NACELLE - ELECTRICAL POWER -SUPPORT BRACKET, IDG POWER CABLE-REWORK OF - CATEGORY CODE
6. - MOD.NAC-24-0001

V2500-NAC-24-0001

Rework of I.D.G. cable support bracket
Fig.1

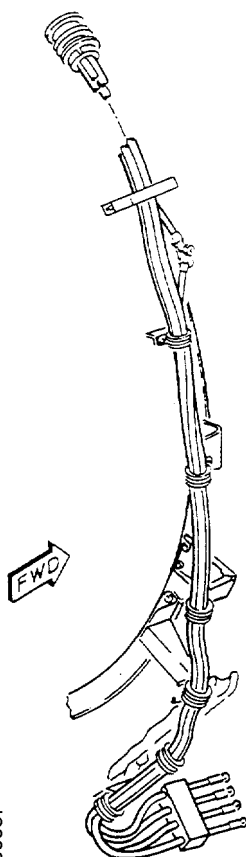
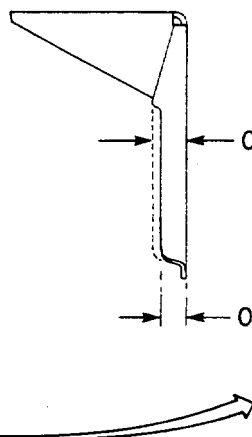
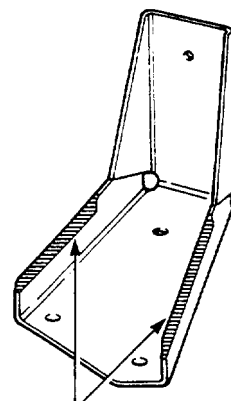
(a) The existing bracket is modified to the new configuration by trimming two parallel edges (See Figure 1.)

- (1) Cut off 0.1 inch from the two edges of the 740-5465-501 bracket as shown (Refer to Figure 1).
- (2) Use a file and round the sharp edges. Remove any burrs.
- (3) Re identify the bracket to new part number 740-5465-503 with a vibro-etch engraver.

REMOVE HATCHED AREAS

RE-IDENTIFY
BRACKET 740-5465-503
